**STATEMENT OF FINDINGS REGARDING THE
APPROVAL OF
THE LIVERMORE VALLEY BASIN ALTERNATIVE**

State of California
Department of Water Resources
Sustainable Groundwater Management Program
Alternative Assessment Staff Report

Groundwater Basin Name:	Livermore Valley (Basin No. 2-010)
Submitting Agency:	Zone 7 Water Agency
Recommendation:	Approve
Date Issued:	July 17, 2019

Figure 1. Map of Plan Area, Livermore Valley Groundwater Basin³³

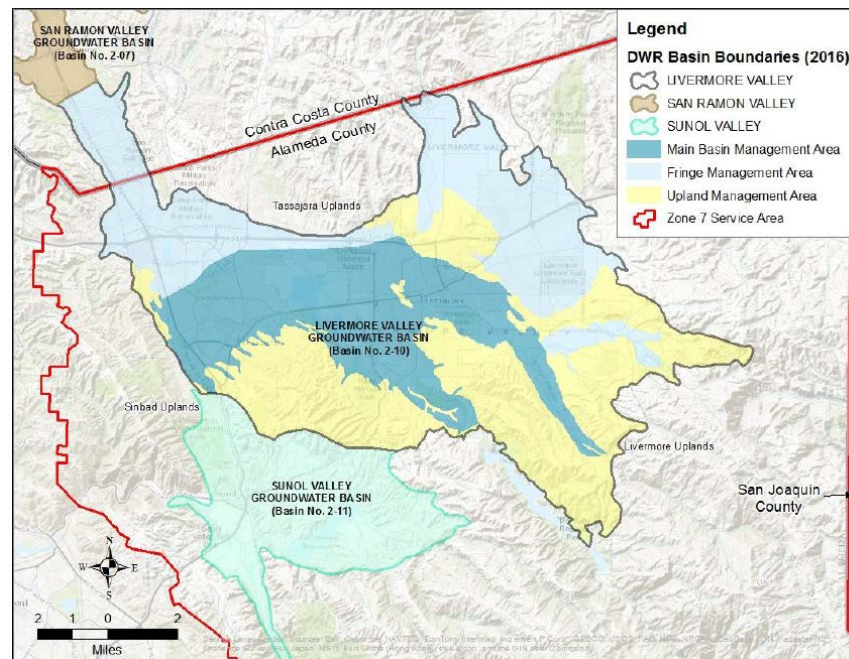
The Alternative addresses the entire area of the Basin as currently defined by the Department. The Agency has jurisdiction over the portion of the basin within Alameda County, which covers most of the basin (Figure 1). For the remaining portion of the basin outside the Agency's jurisdiction that extends into Contra Costa County, the Agency has developed a memorandum of understanding with those agencies with jurisdiction including Contra Costa County, Contra Costa Water Agency, the City of San Ramon, the East Bay Municipal Utility District, and the Dublin San Ramon Services District. The MOU gives the Agency the delegated authority to be the GSA for the portion of the Basin outside of the jurisdiction of the Agency, which is located within the jurisdictions of those agencies listed above.³²

Based on the facts provided, Department staff determined that the Alternative covers the entire Basin.
